Docket Item # 6 & 7
BAR CASE # 2010-0358/359

BAR Meeting
January 5, 2011

ISSUE: Permit to Demolish/Encapsulate and Addition/Alterations

LOCATION: 410 South Lee Street

Figure 2. Existing (east) rear elevation with neighboring properties.

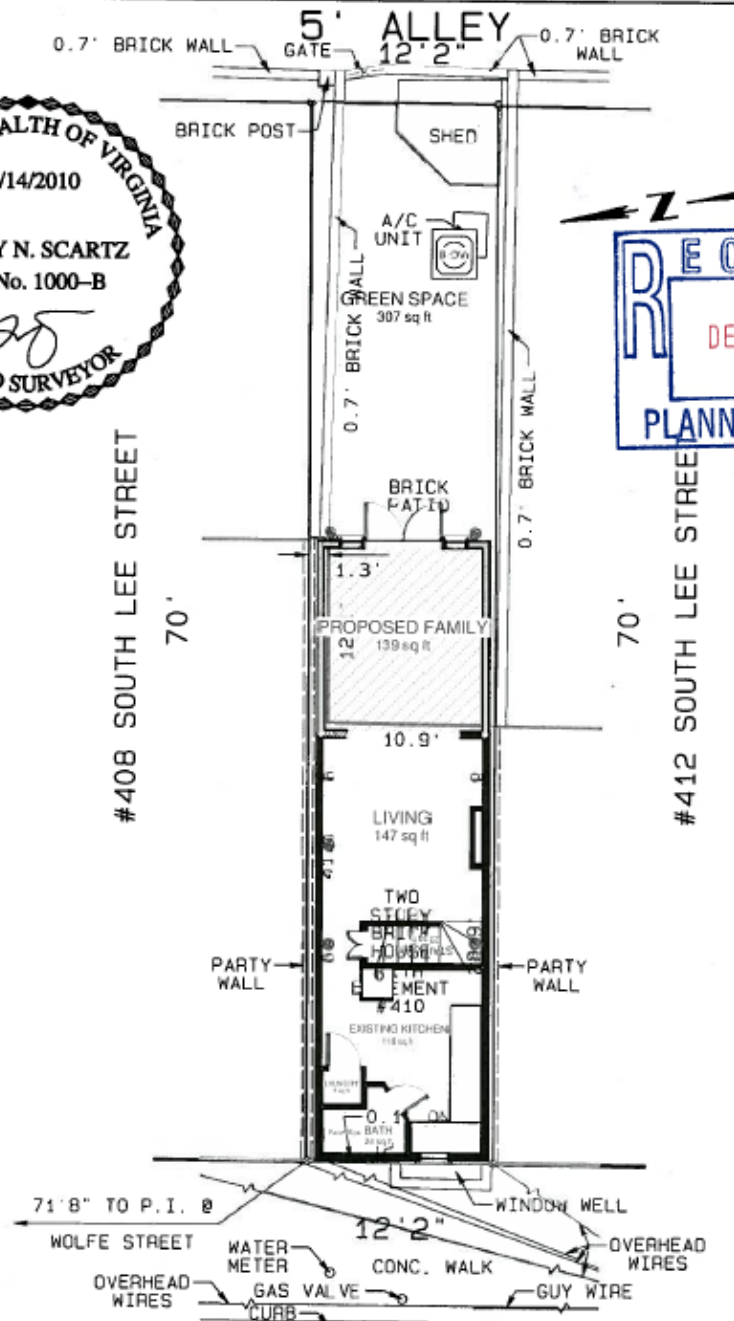
In the opinion of Staff, none of the criteria for demolition and encapsulation are met and the Permit to Demolish/Encapsulate should be granted. The area proposed for demolition and encapsulation is located on a secondary elevation, does not remove any portion of the building containing character defining features of uncommon design or historic merit, and does not compromise the integrity of the building as a whole. Rear additions typically encapsulate/demolish the entire rear elevation; however, in this instance the area is limited to the basement and first story—the second story rear wall will remain.

Figure 4. Plat.

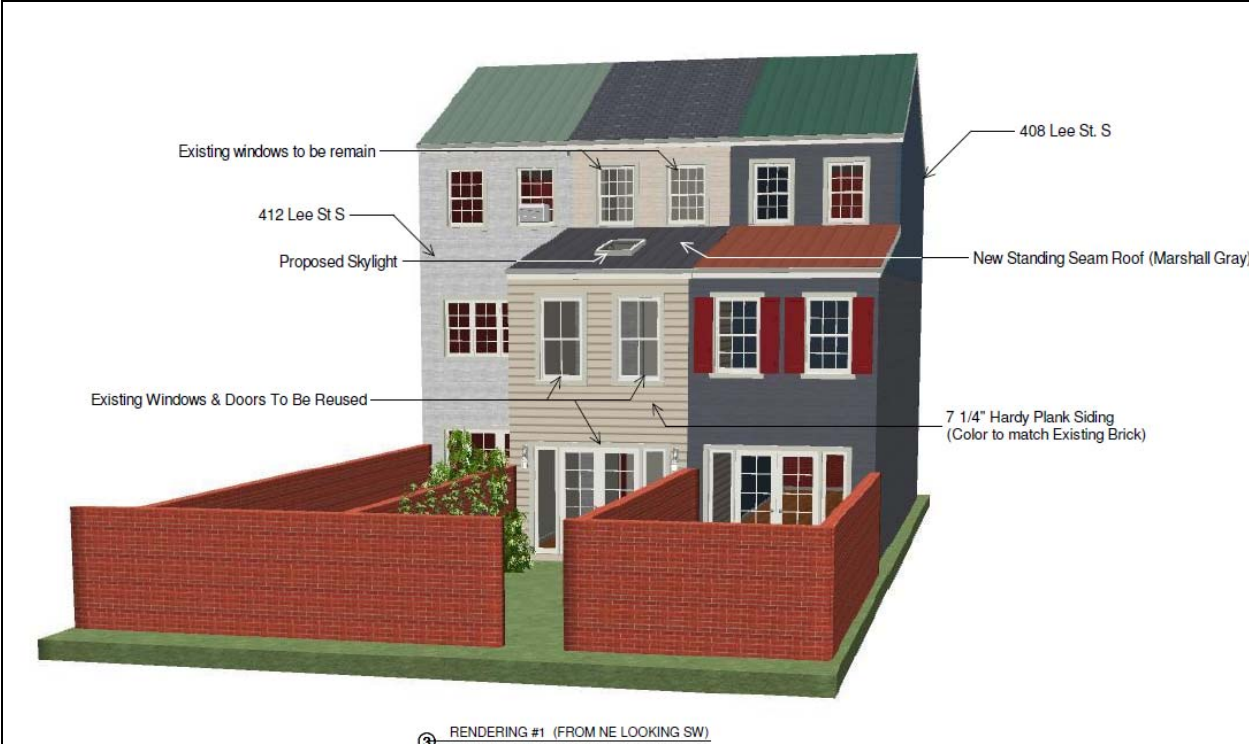
Although the drawings suggest the removal of a portion of the brick wall located between 410 and 412 South Lee Street, the survey plat indicates that this brick wall is located entirely on the property of 412 South Lee Street. Staff confirmed with the applicant that no alterations are proposed to the brick wall and that it will remain in its current condition and location.

1. That the fiber cement siding be smooth (rather than with a simulated woodgrain) and that the nails not show in the installation;
2. That the plans be revised to illustrate that the brick wall on the adjacent property will be retained as is as part of the building permit application;

Figure 5. Rendering of proposed addition, looking southeast.

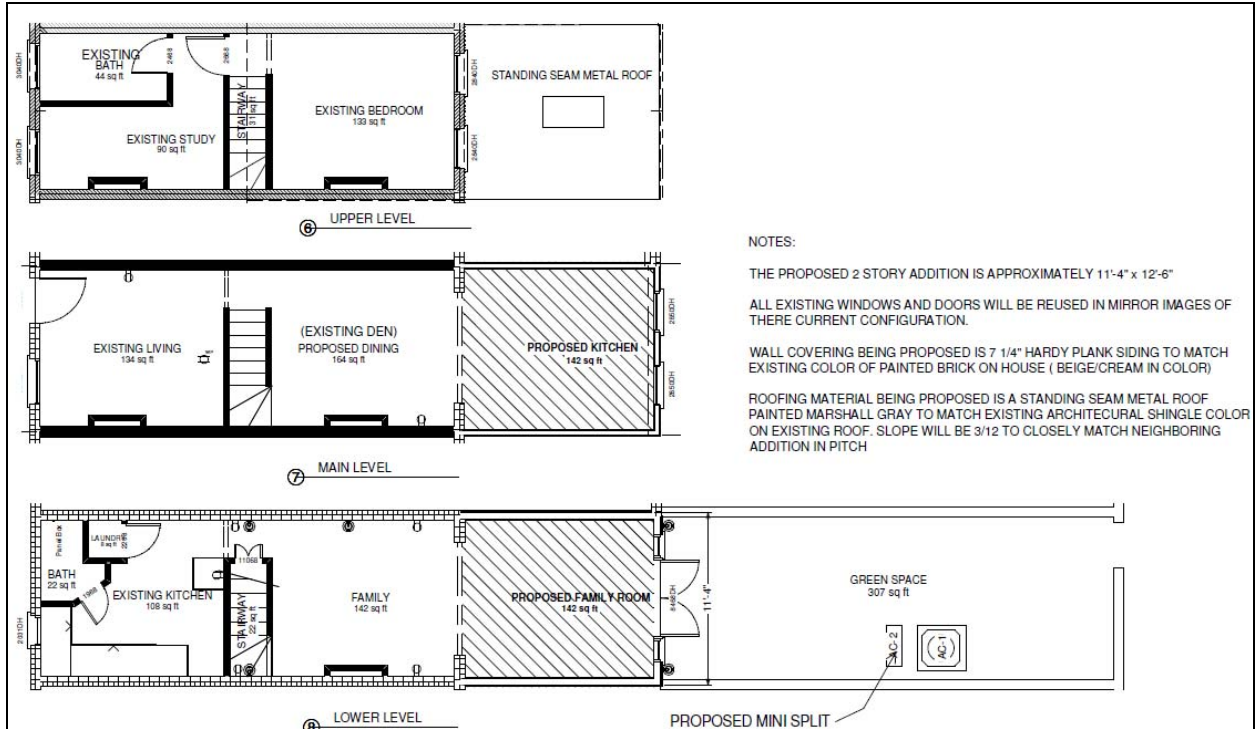
The construction of an addition to any building within a historic district must be evaluated not only for its impact on the building to which it is being attached, but also for its impact on the district as a whole. The *Design Guidelines* encourage “designs that are respectful of the existing structure and which seek to be background statements or which echo the design elements of the existing structure.” As the attached drawings illustrate, the proposed addition will not overwhelm the existing building and will clearly read as a separate and distinct addition. The use of frame construction and a shed roof result in an appropriately simple addition for this townhouse. The addition is generally appropriate in respect to massing, scale and form, like many additions found throughout the district. Because of the change in grade on this lot, the existing two-story townhouse is, effectively, three stories tall on the rear. This proposed two-story addition is the same height and will extend to the same depth in the rear yard as a similar two-story addition at the adjoining townhouse to the north at 408 South Lee Street (Sanborn Fire Insurance Maps indicate the addition was constructed between 1921 and 1941). The proposed addition will be moderately visible from Potomac Court when there is not foliage on the trees.

The proposed materials are appropriate for an addition and contribute to the compatibility of the alterations with the historic building. The Board has regularly approved fiber cement siding on new construction and additions and Staff notes that it will help differentiate the addition from the historic fabric. The choice of a standing seam metal roof and a flat skylight are also appropriate.
